SERVICE BULLETIN

DATE: 03-28-2017 **BULLETIN NO:** 17-002A

TITLE: 6700SJ2PD Sauer Drive Pump Replacement

ORDERING SAUER DRIVE PUMP

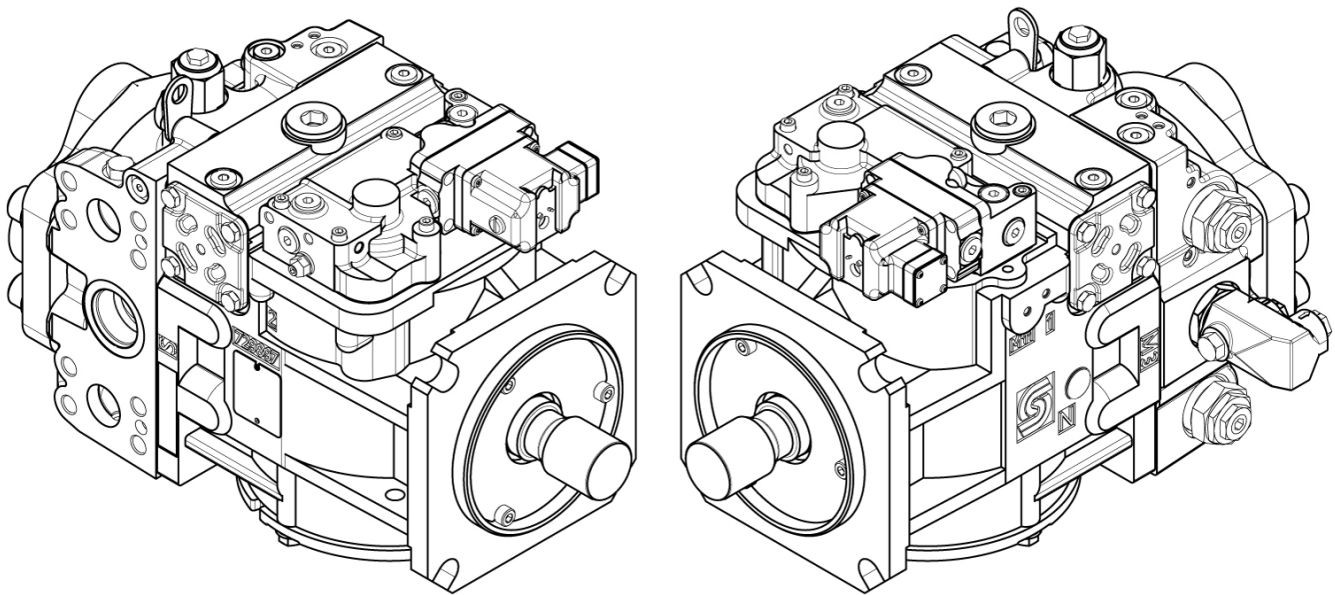
SUMMARY: Certain Model 6700 machines since 2007 use a 130cc Sauer Drive Pump, part number 2013679. In certain instances of when contamination is introduced, the machine could experience unintended movement. This pump is being obsoleted, and replaced with a new pump, part number 5072739. The new pump is a direct replacement. It has standard Ma and Mb Relief Cartridges versus the Multi-Function Reliefs in the existing pump. Internal changes in the new pump will also provide improved reliability.

The Multi-Function valve cartridge (5015047) in the original pump will not work in the new pump.

ACTION: Order the new Sauer pump (5072739) as necessary. If ordering the old pump part number (2013679) the new one will be sent in its place.

1. Contact the Parts Department at Harsco Rail to order the Sauer Drive Pump (#5072739).
